Final Drainage Report  
Terra Ridge North  
Colorado Springs, Colorado 80908

February 16, 2023  
PCD File# SF2239

Figure 12-21. Embankment protection details and rock sizing chart (adapted from Arapahoe County)

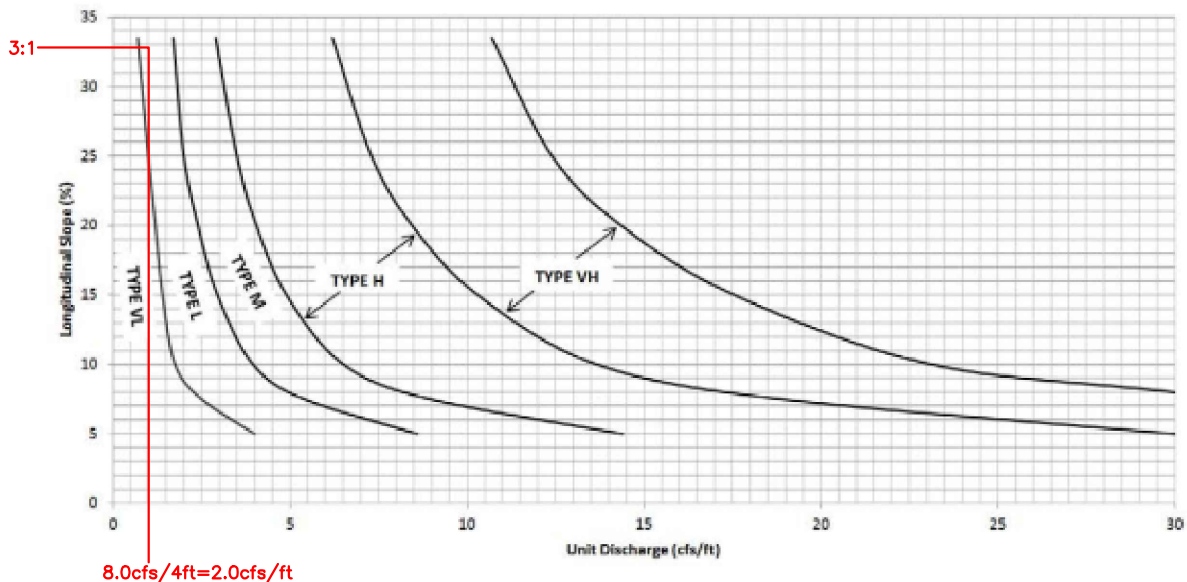
Unresolved Review 1 comment: Discuss in FDR text why a cutoff wall is not necessary.

DEVELOPED DRAINAGE PLAN

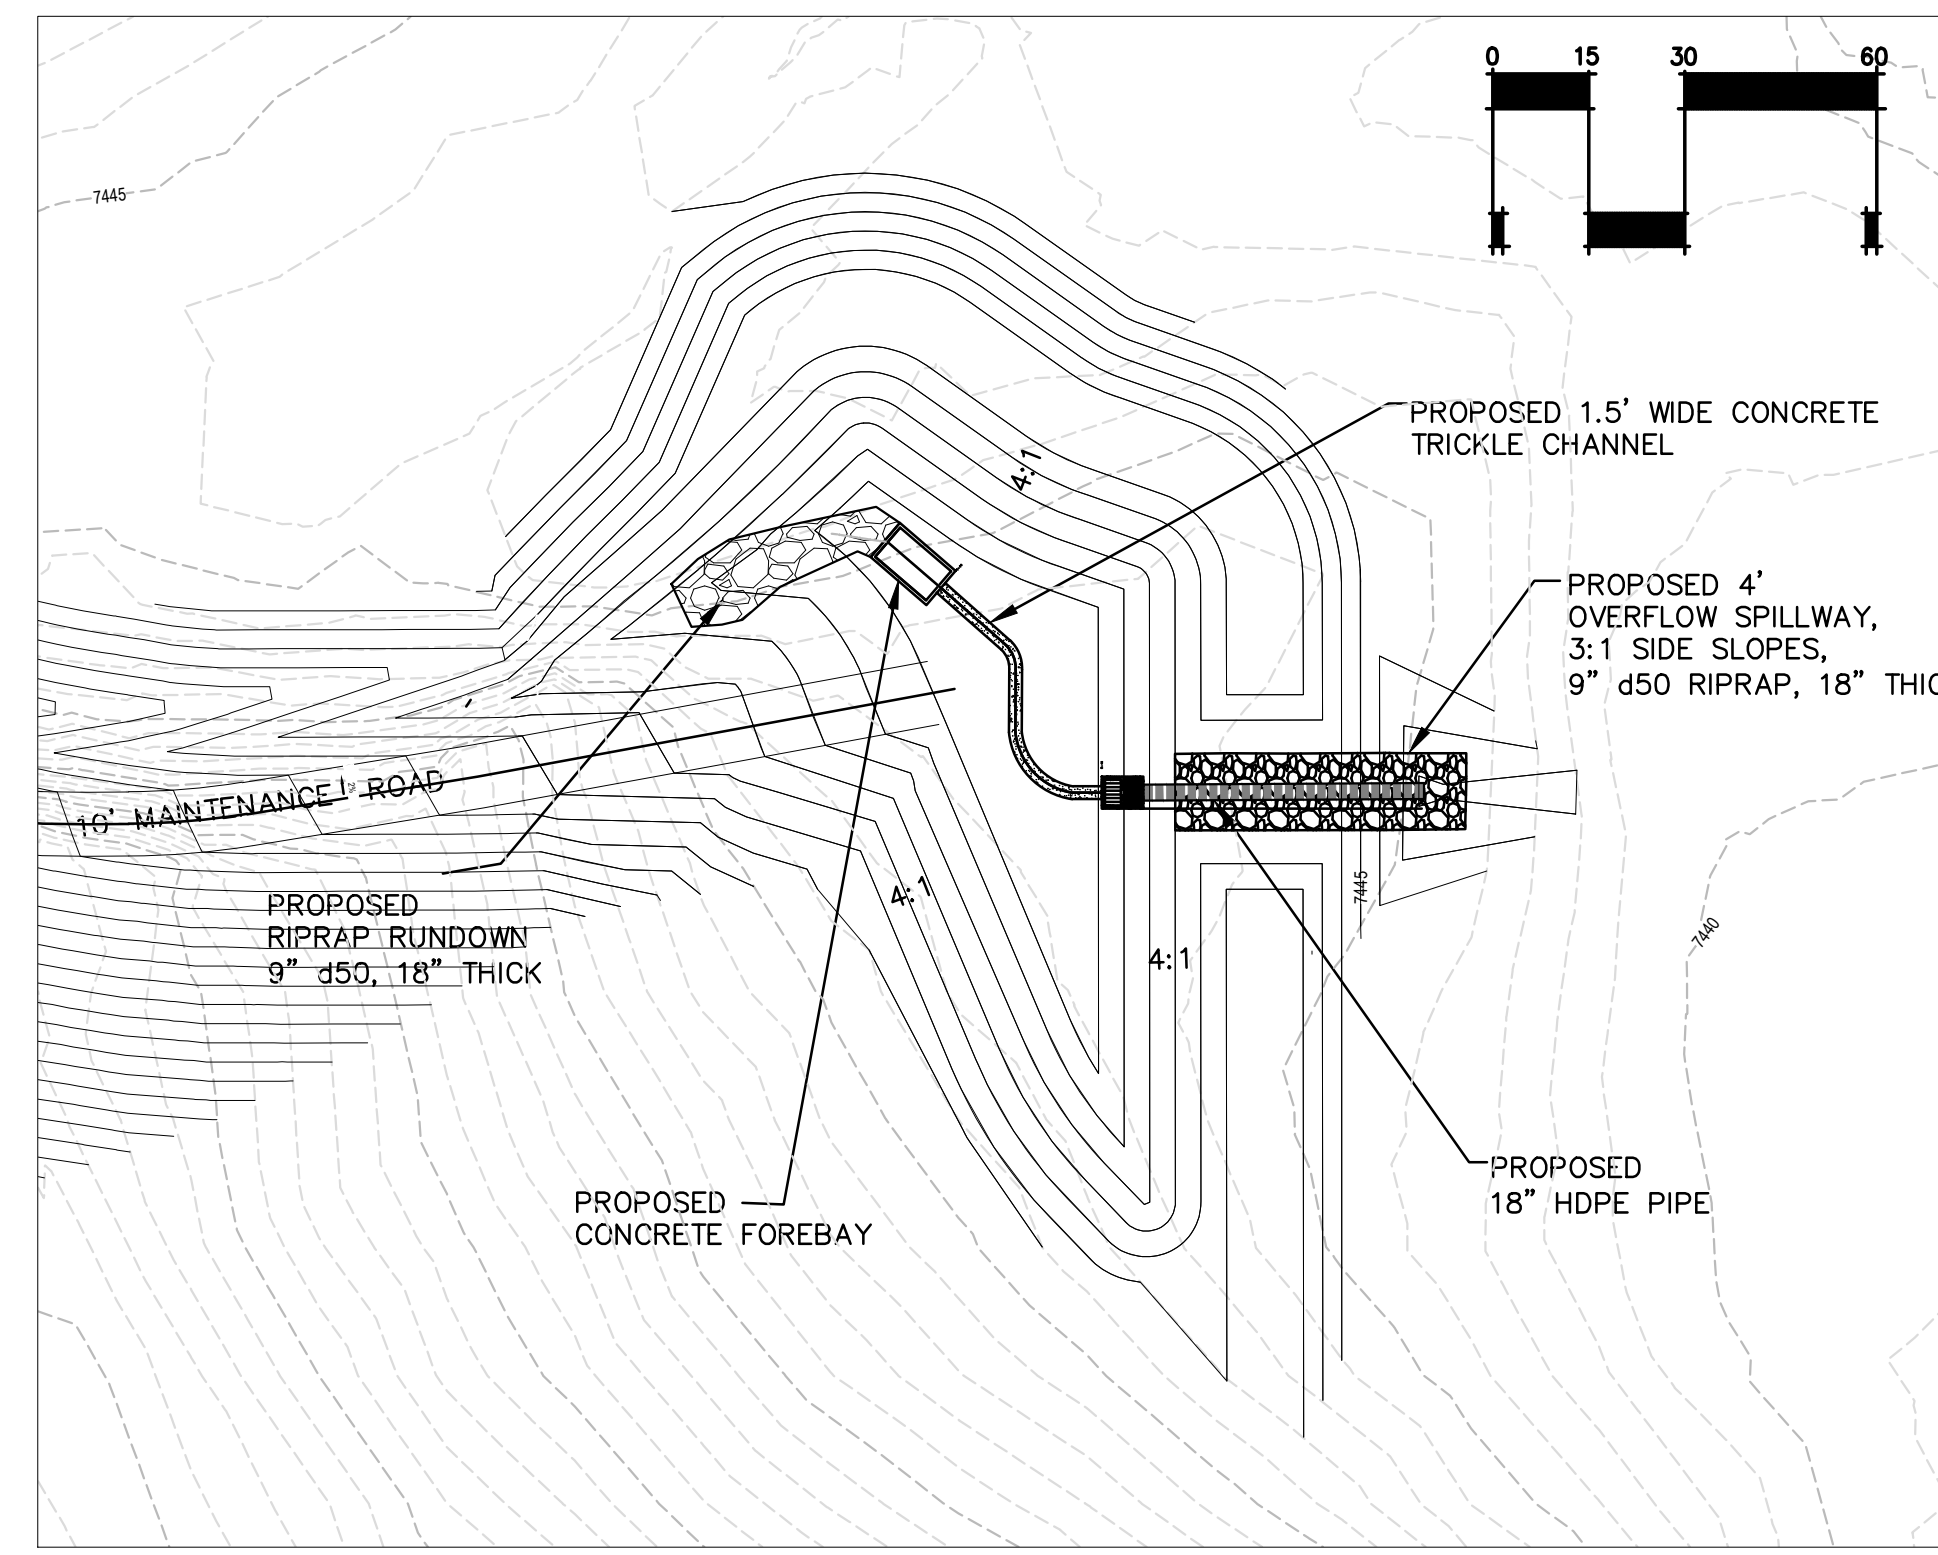
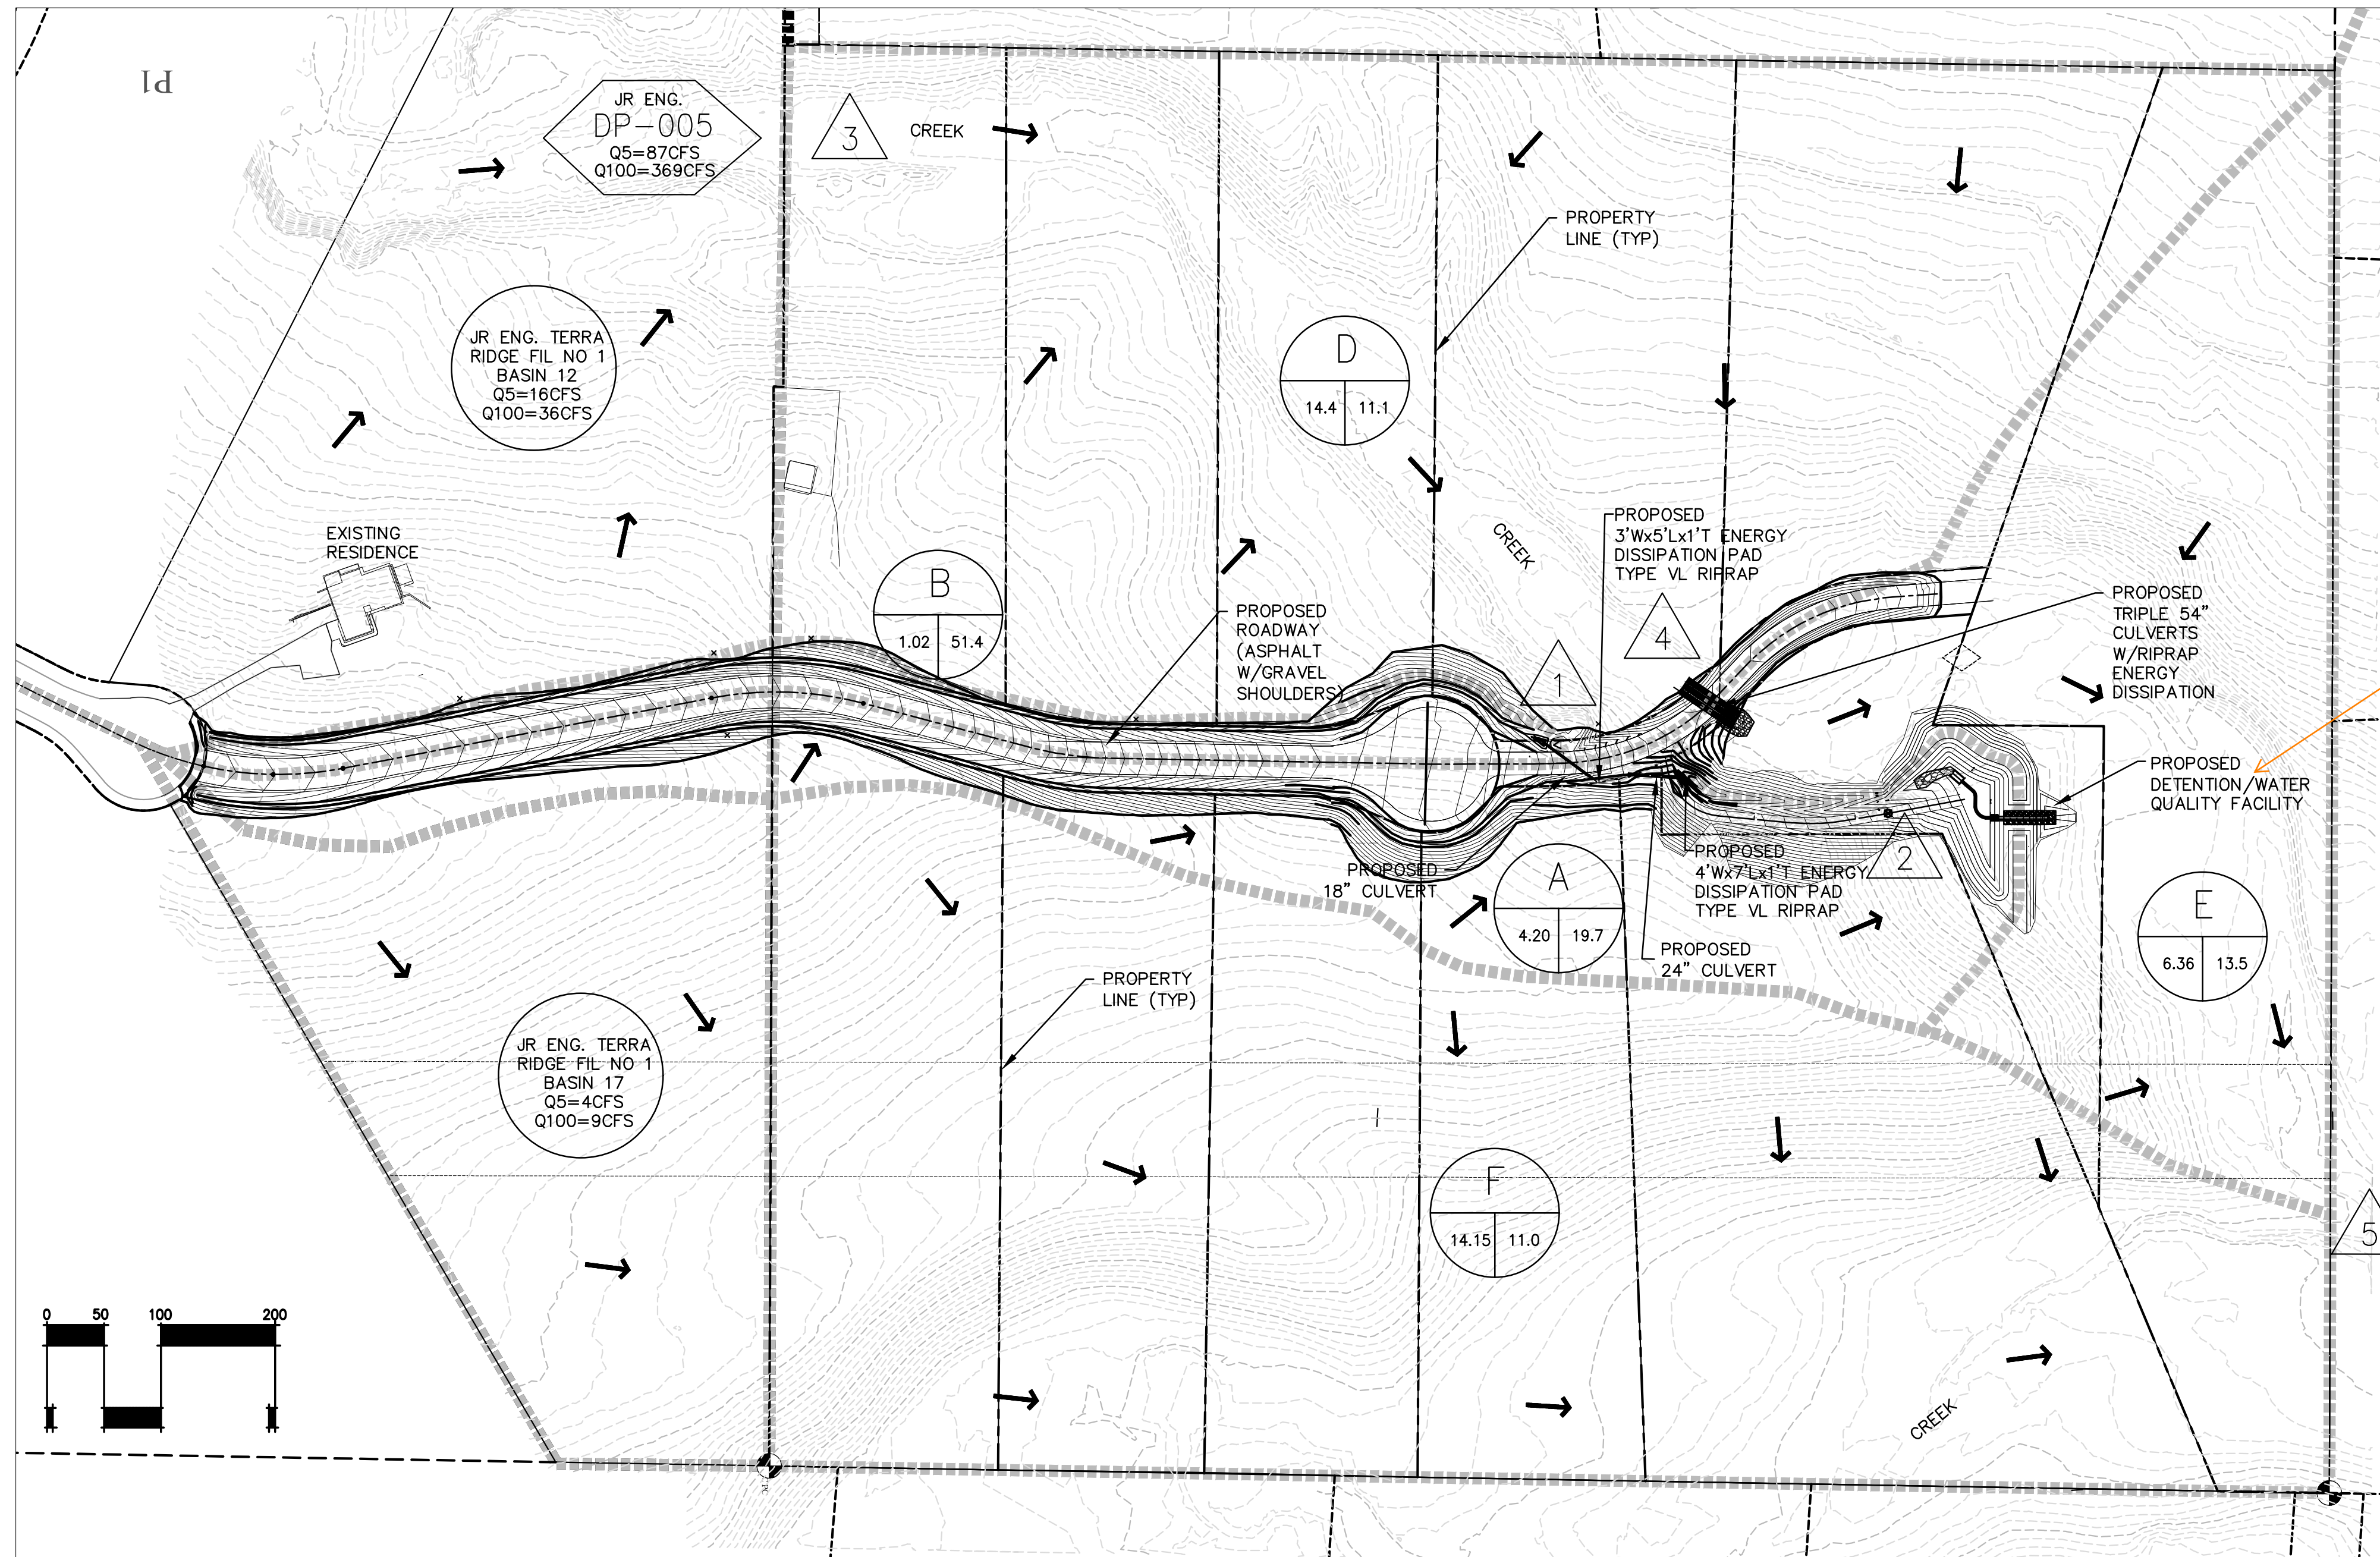
Unresolved Review comment:  
In the Proposed Drainage section above, also add a paragraph or two for the proposed roadway improvements for this project (Fox Creek Lane) that are South of this project (Terra Ridge North) within Terra Ridge F1 (as shown on the drainage map on pdf page 66 below).

This table can be added to the report text above or inserted into the existing drainage map on pdf pg 66 below.
